**City of Lino Lakes
Environmental Board Meeting
September 24, 2014
6:30 p.m.**

**ENVIRONMENTAL BOARD
AGENDA ITEM 5A**

PROJECT NAME: White Pine Senior Living

REQUEST: Rezoning to R-4, High Density Residential, Preliminary Plat Review, Conditional Use Permit for Nursing Home.

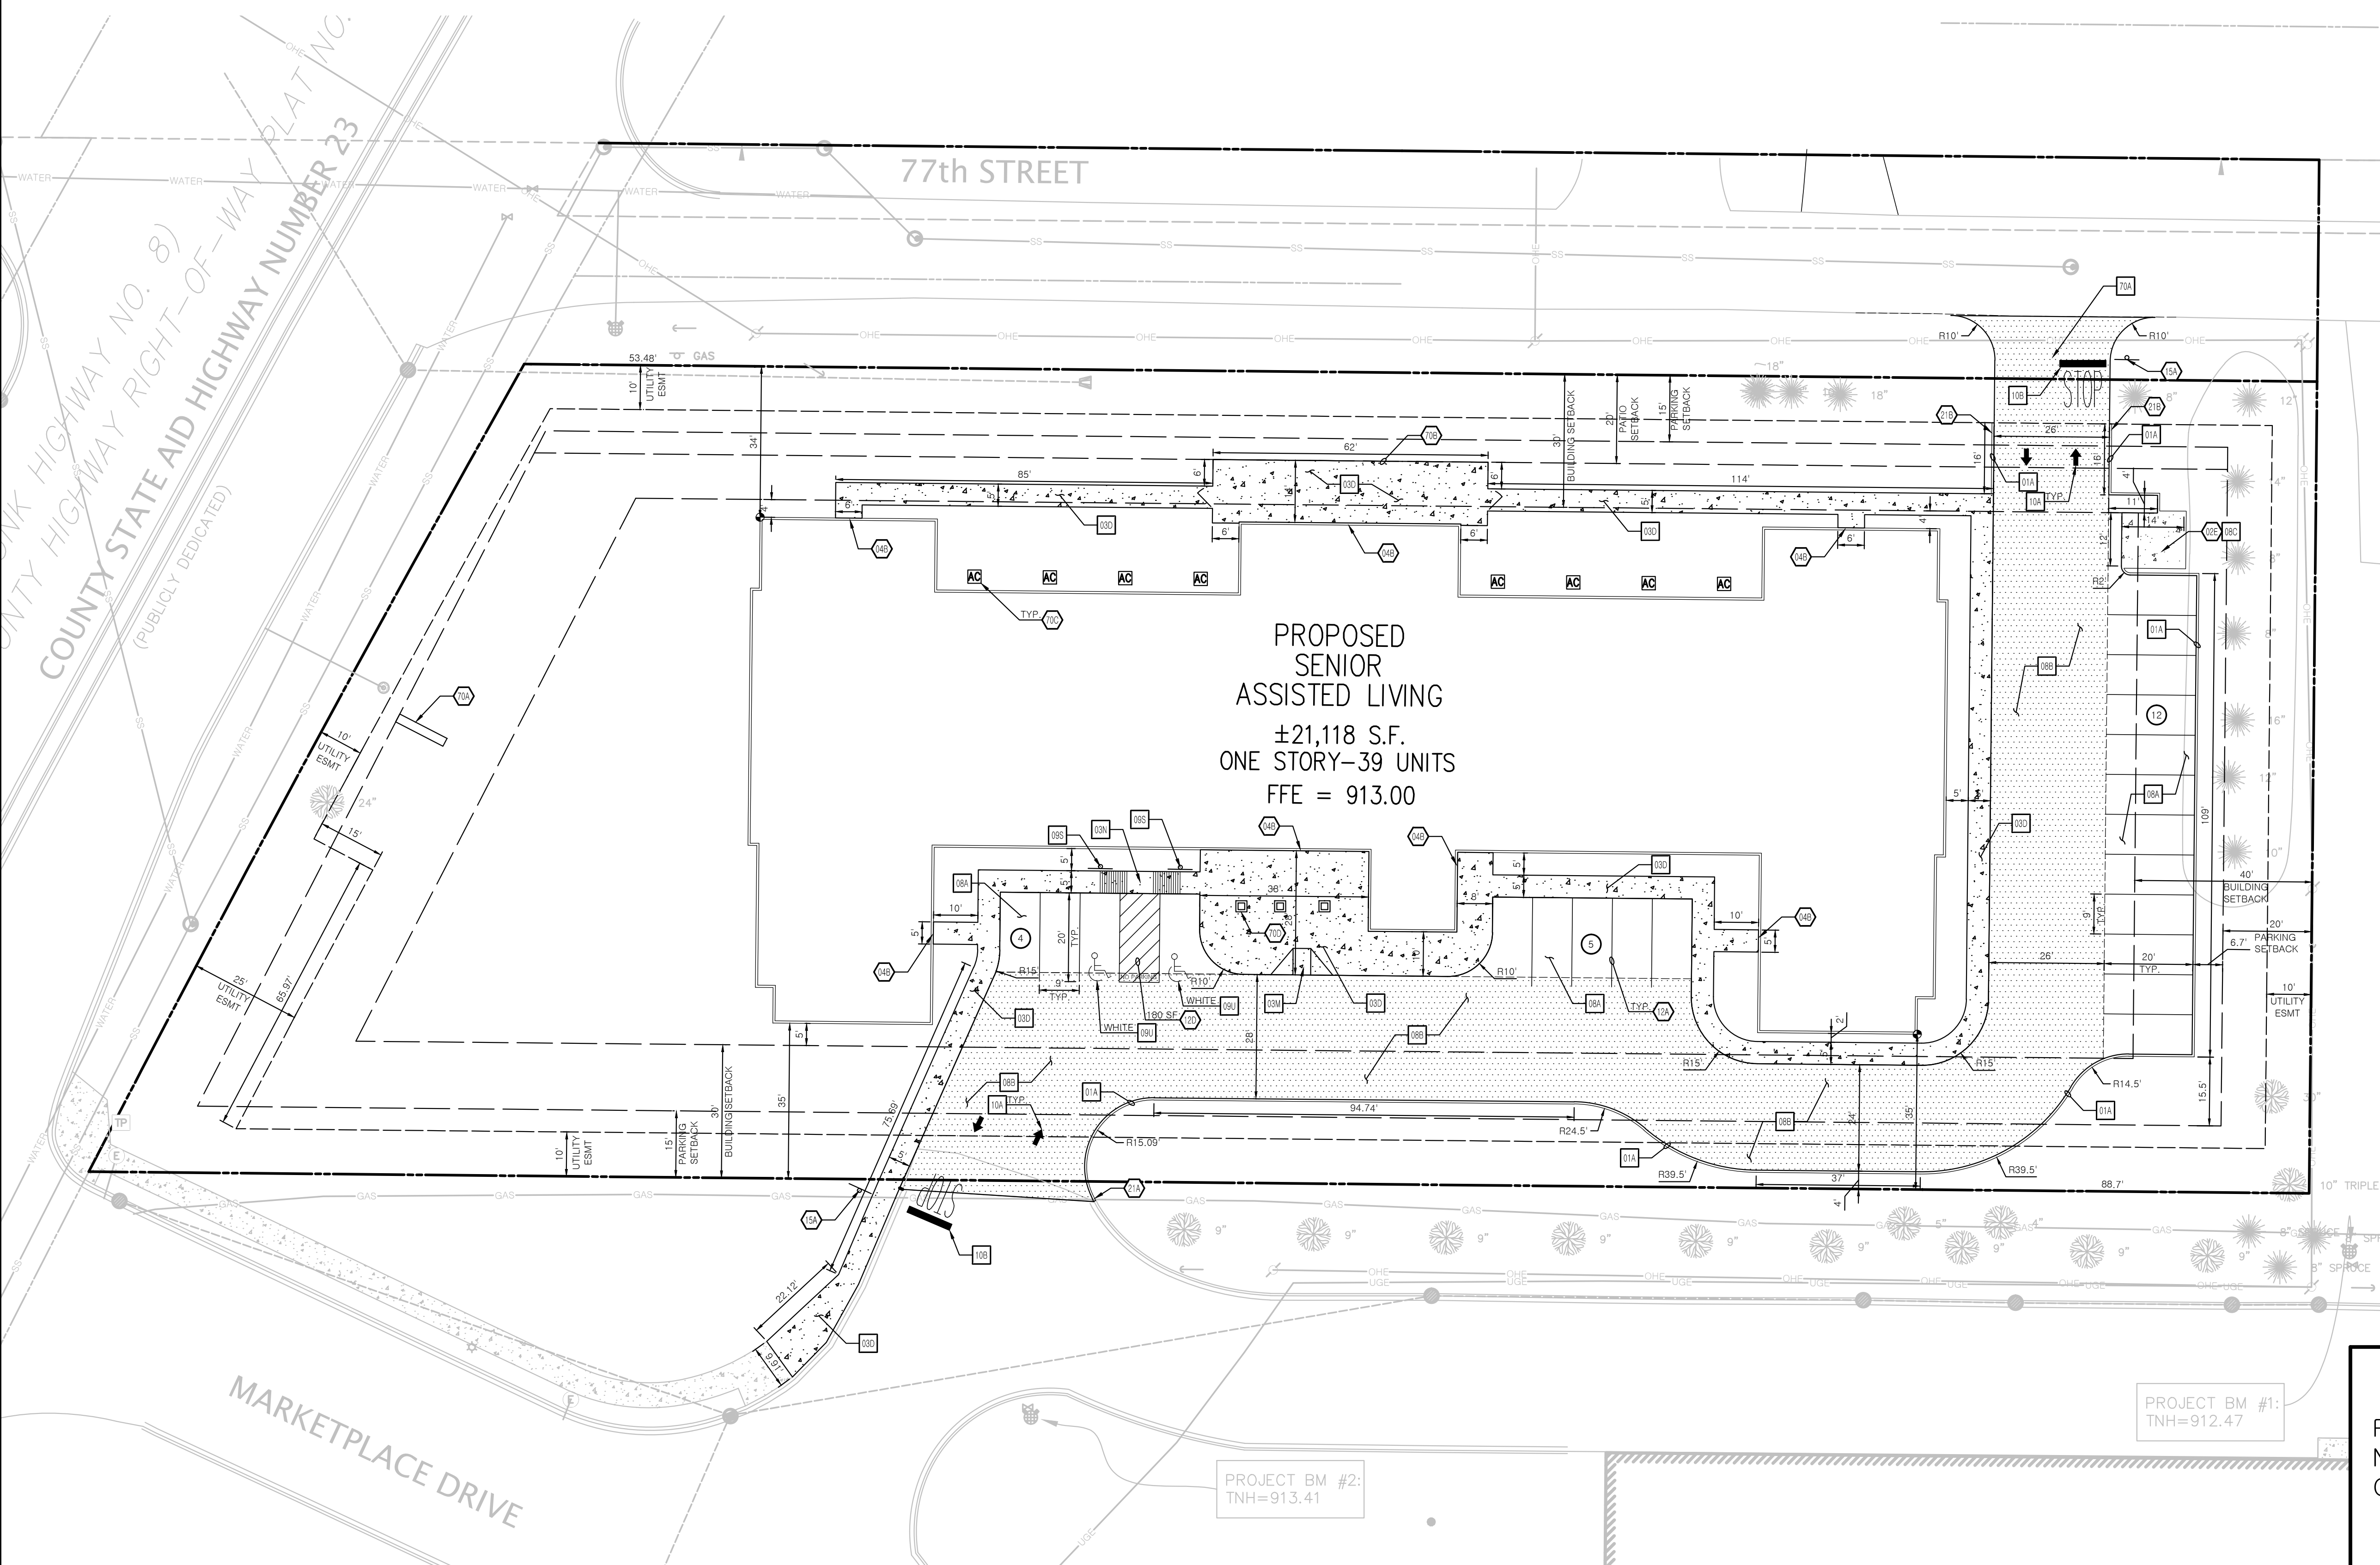
The landscape plan must show screening on at least 3 sides. Red Pines on the east side are effectively screening the adjacent property. There are new Junipers and Freeman Maples with existing Green ash on the boulevard that is proposed for the south side. The Green ash are about 20 feet tall and are not part of the project but do add to effective screening.

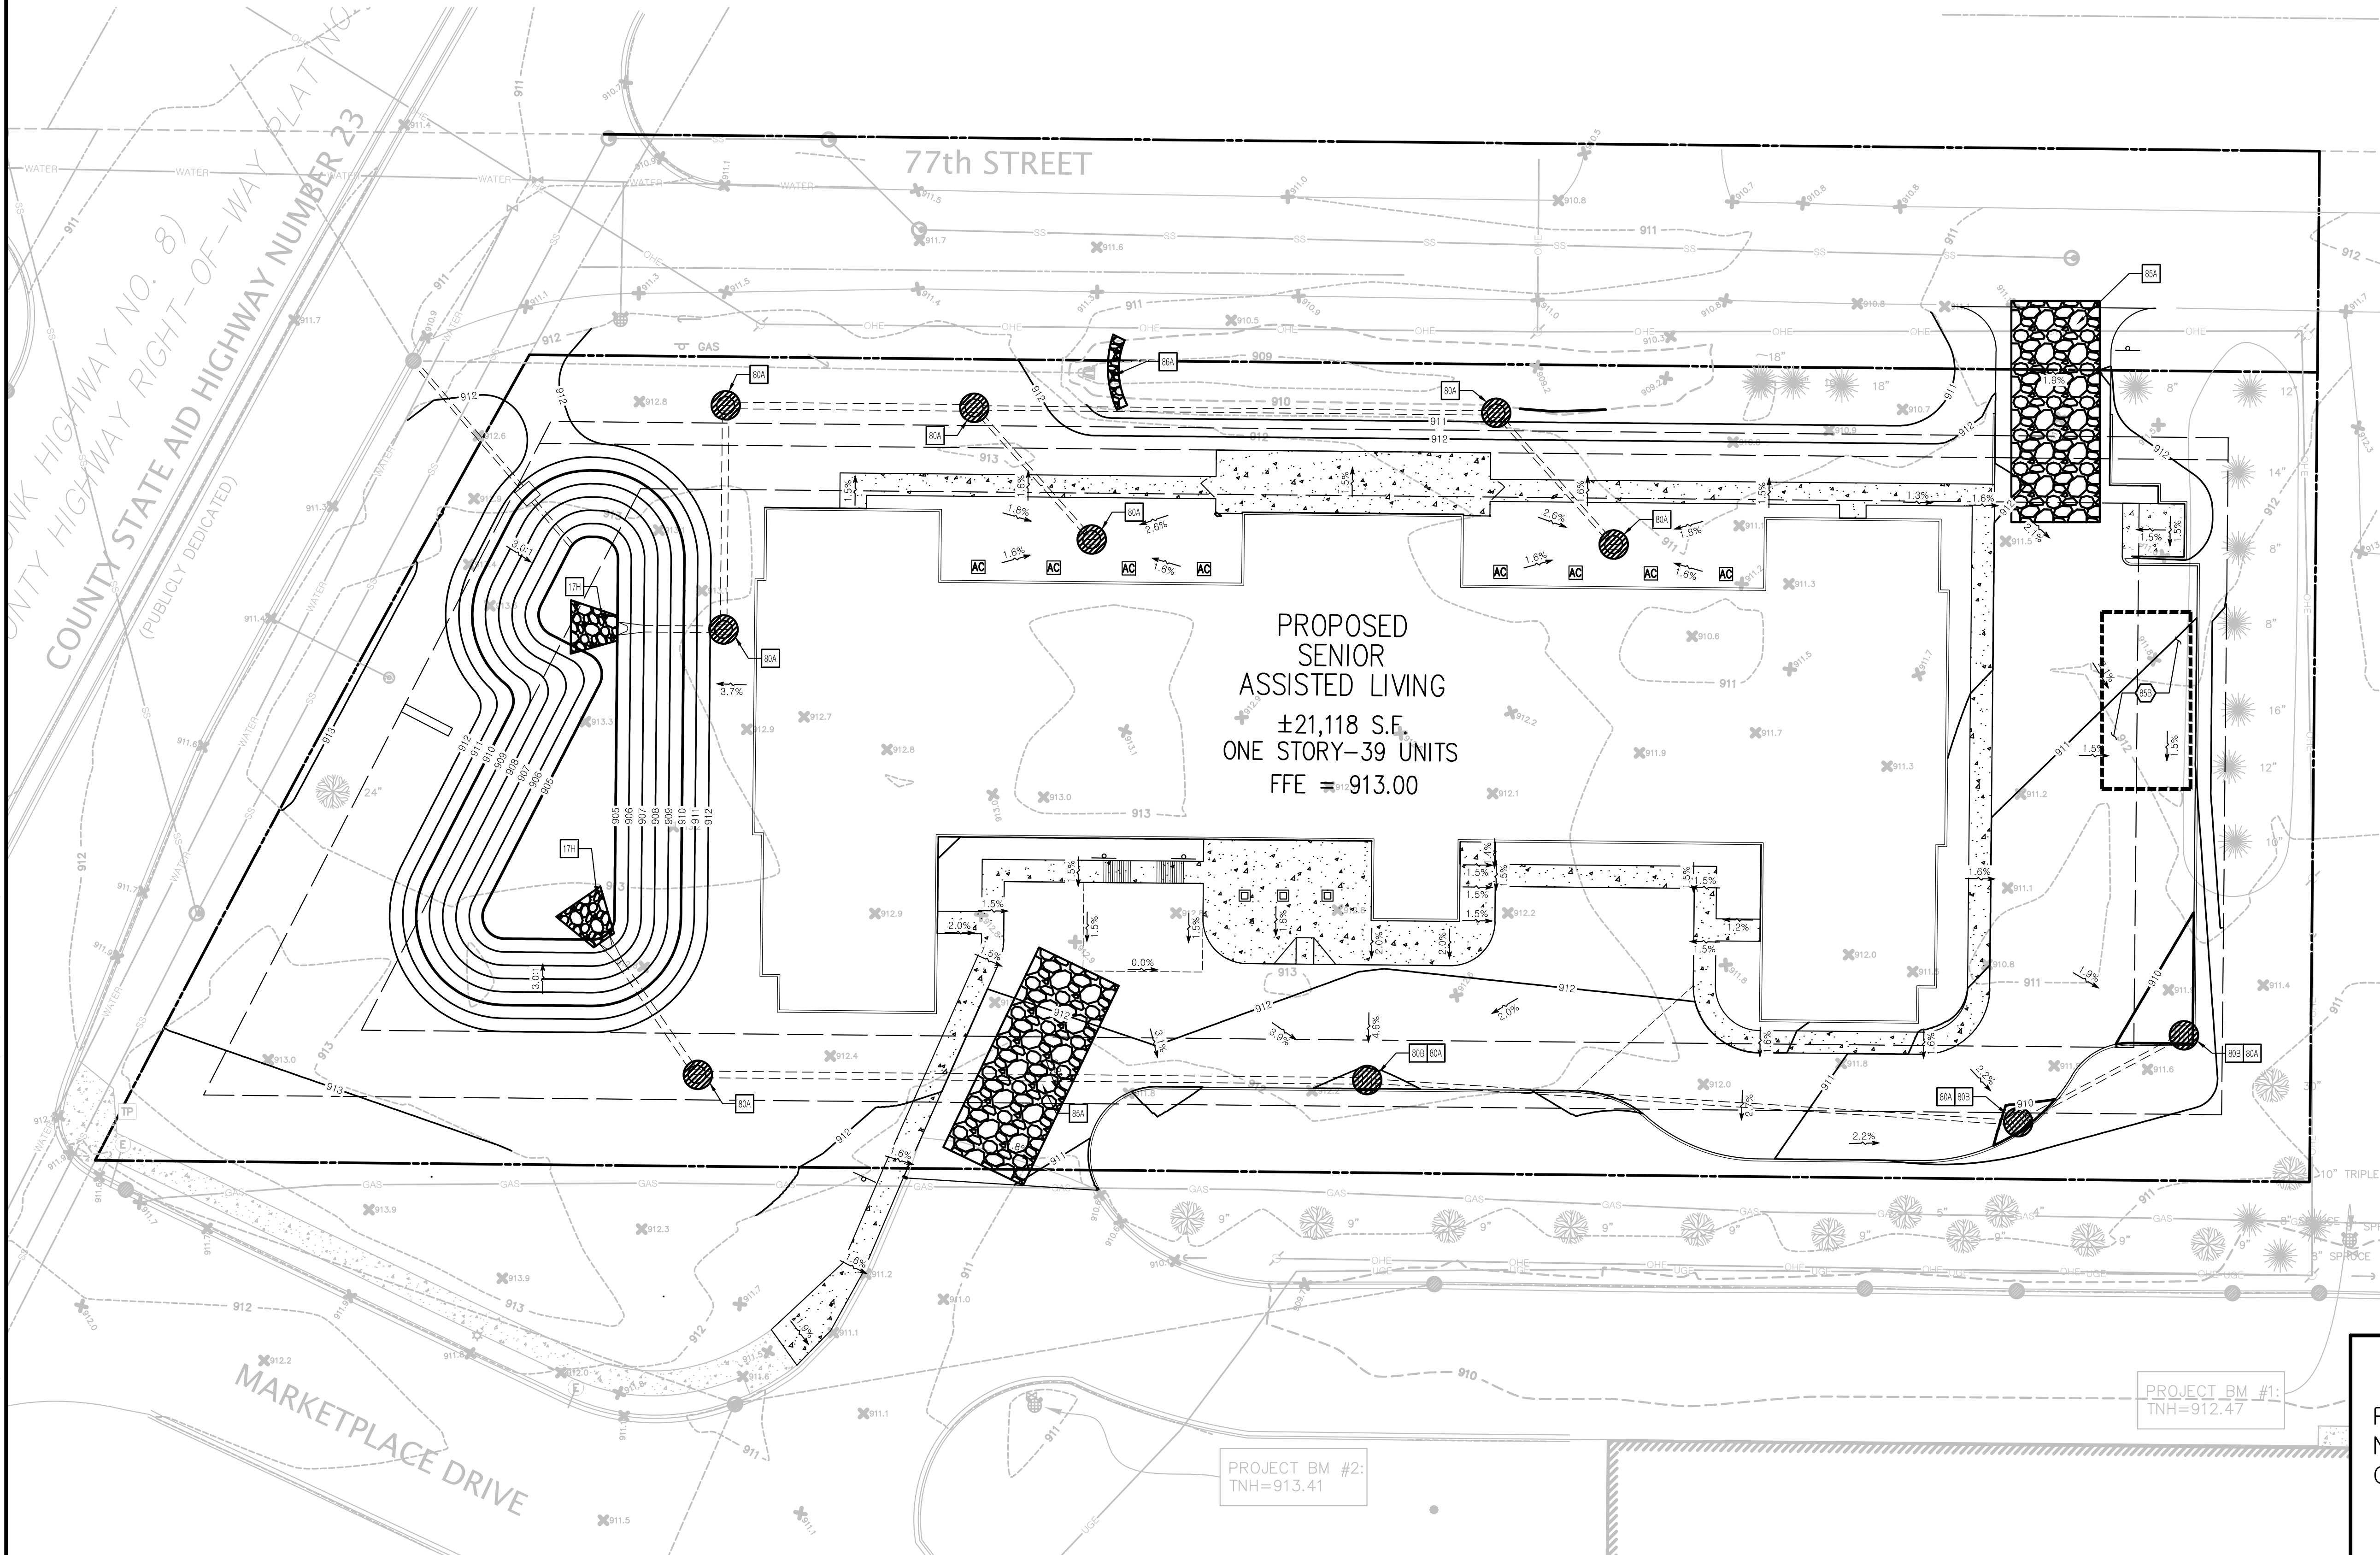
Since the site will have over an acre of disturbance, an MPCA permit is required and a SWPPP that meets the guidelines of the issued permit.

In addition to the SWPPP plan sheet, the SWPPP must include specific requirements of the MPCA permit. Items include:

- Proposed erosion prevention and sediment control BMP's to control the discharge of sediment and/or other pollutants from the site, particularly at the point (s) of intended discharge.

- Must provide the knowledgeable person/chain of responsibility information. We need the name of the person that is knowledgeable and experienced in the application of erosion prevention before and during construction. The owner must identify who will have the responsibility for long-term operation and maintenance of the permanent stormwater management system. The owner must include in the SWPPP a chain of responsibility with all operators on the site, or if not known, the title or position of the responsibility of responsible party, to ensure that the SWPPP will be implemented and stay in effect until the construction project is complete, the entire site has undergone Final stabilization and a NOT has been submitted to the MPCA.

- The permittees must provide training documentation that the individuals listed as SWPPP overseers are certified by a MPCA approved training method. With that the City would need names of the person or persons involved with SWPPP management, dates of training and the names of instructors of entity providing training, and the content of the training course or workshop including the numbers of hours training,

- Location of the SWPPP on site and the location of all required weekly, post-rainfall event inspections and follow-up corrections
- The SWPPP must incorporate the requirements (MPCA Stormwater Discharge Design Requirements) including calculations for the project. The submitted SWPPP simply states it will be kept at the construction site.

- Site specific quantities must be included for all erosion prevention and sediment control BMPs.
- Must include maps of all surface waters and wetlands, and stormponds or basins that can be identified on maps such as a USGA 7.5 minute quadrangle map, the NWI maps or equivalent maps within one mile (aerial radius) from the project

boundary that will receive stormwater associated with construction activity during or after construction.

- The SWPPP must describe a maintenance plan identifying who will be performing future maintenance of permanent stormwater treatment systems on the site.
- The SWPPP must identify if the projects stormwater flows to an impaired water within 1 mile of the site (aerial radius), and whether or not there is USEPA-approved TMDL for pollutants or stressors for the site. The permittee must identify those TMDLs applicable to the to the projects stormwater discharge.
